Subject: Amended MHI's Response to US-APWR DCD RAI No. 804-5938 Revision 3 (SRP 03.12)

Amended Response to Request for Additional Information
No.804-5938 Revision 3

US-APWR Design Certification

QUESTION NO.: RAI 03.12-26

Figure1 SG Lower Lateral Support

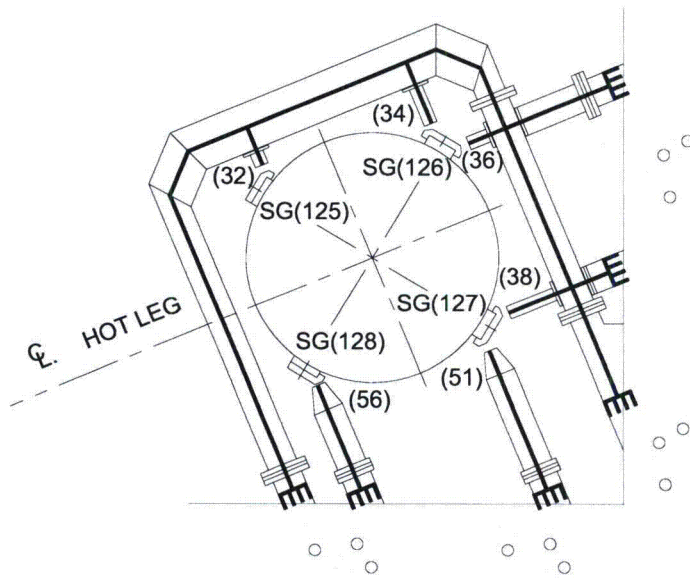
In RAI 03.12-16 response, MHI stated that SG lower lateral support will be installed to not restrain thermal expansion. The gap between SG and SG lower lateral support will be adjusted so that support will come in contact with SG only during operating condition. Figure 3.8.3-2 (Sheet 3 of 4) does not provide sufficient detail, the staff is requesting MHI to provide lower lateral support structure information and geometrical thermal calculation to ensure that there is enough clearance between the two supports closer to hot leg and SG during cooldown.

For the support design, such as the SG lower lateral support, the time history analysis method, considering both effects of non-linear one-direction supports with small gap and the building frequency shift of $\pm 15\%$ will be selected. Gaps shall be controlled to be less than [] inch. As a consequence of the hot functional test, as presented in Figure 1. The non-linear support model is presented in Figure 2.

Gaps between SG lower shell and the lateral support shall be controlled to be less than [] inch, after the hot functional test.

Figure 2 Non-Linear Support Model

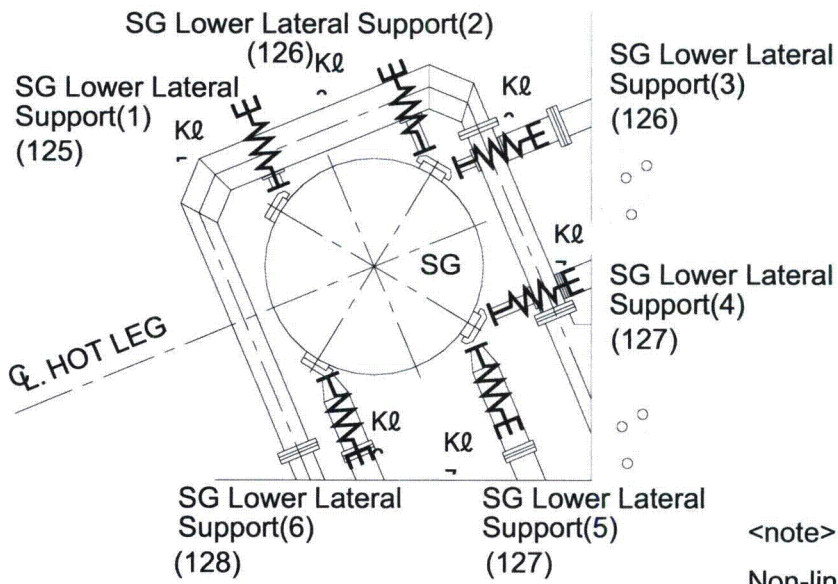
DCD Tier 2, Figure 3.8.3-2 showed SG lower support structure drawing. Two supports (parallel to hot leg) of SG lower lateral support structure functioned as non-linear one-direction supports. In general, non-linear dynamic analysis is analyzed using time-history direct integration method. The response spectra method or time-history modal is used in linear elastic dynamic analysis. The staff is requesting MHI to provide basis for using time-history modal, or response spectra methods for the non-linear support system. The staff also requests MHI to clarify which method is used for the RCL piping analysis and put the correct method in the DCD.

Non-linear properties are considered in the time history analysis with direct integration.
